REMARKS/ARGUMENTS

Amendments to the Drawings:

Appl. No.: 09/855,018
Amdt. dated: March 31, 2005
Reply to Notice of Non-Compliant Amendment of March 17, 2005

FIG. 8

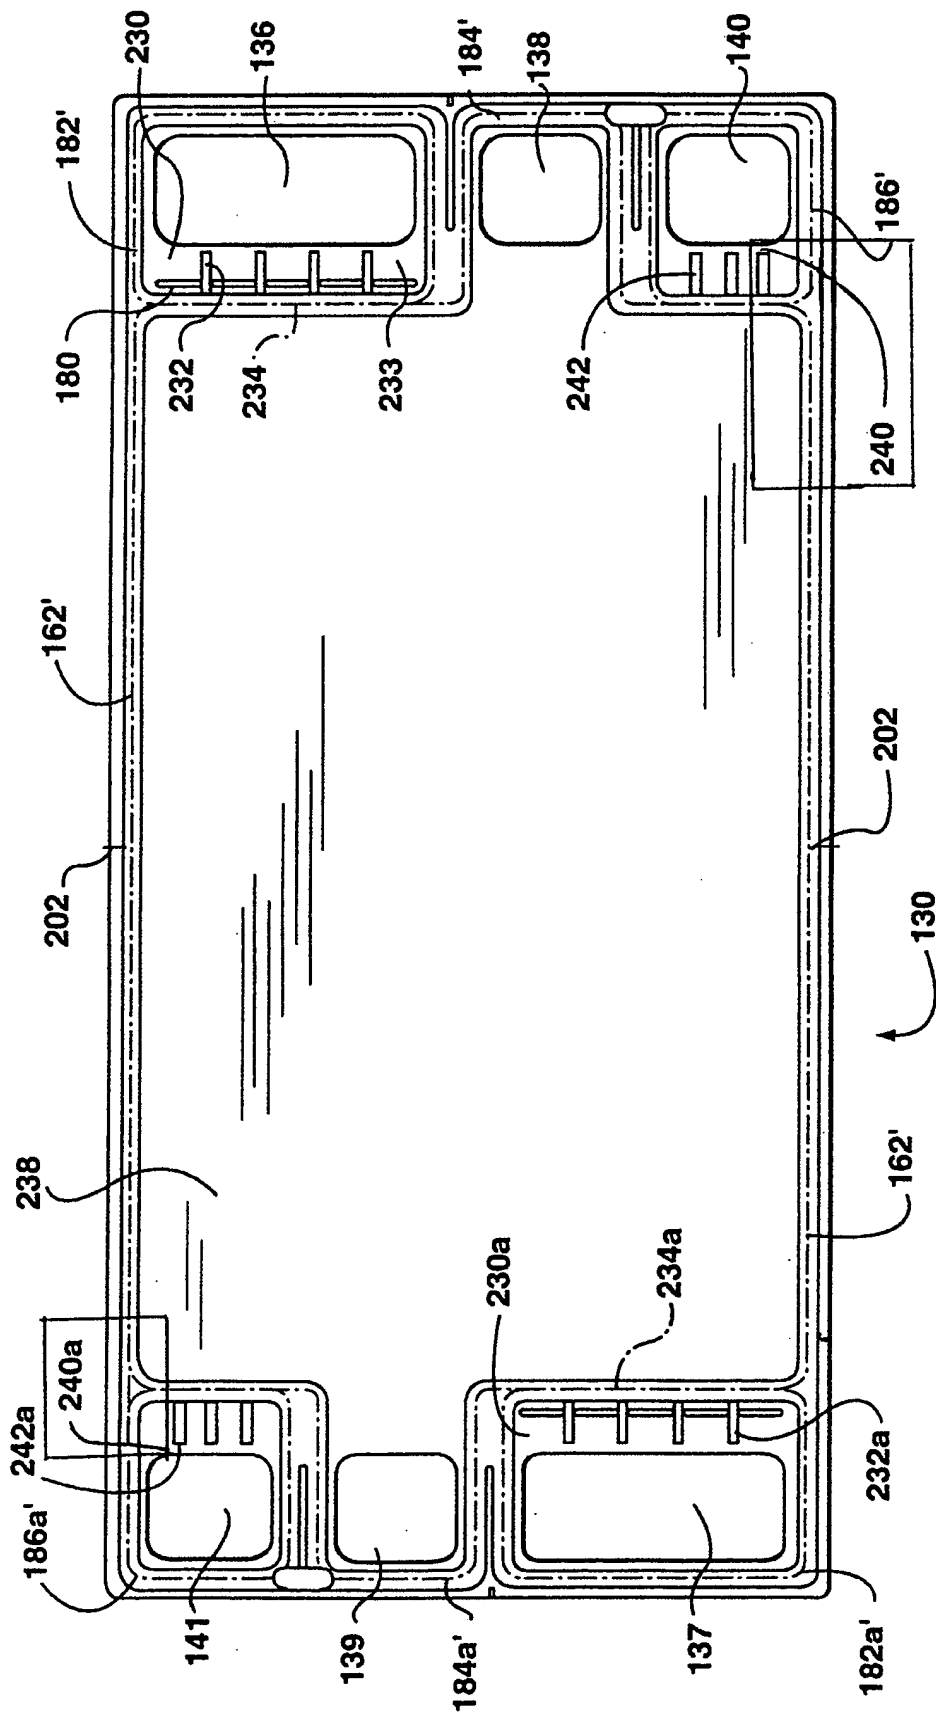
The attached drawing sheets include one set of replacement drawings for Figures 4 and 8 and a set of annotated sheets showing the changes made to Figures 4 and 8. Support for the Figure amendments is on line 24 of page 17 and lines 24-32 of page 18 of the application as filed.

With regards to Figure 8, the leader lines for labels 240a and 240 have been changed to better describe the extension elements associated with apertures 140 and 141 respectively.
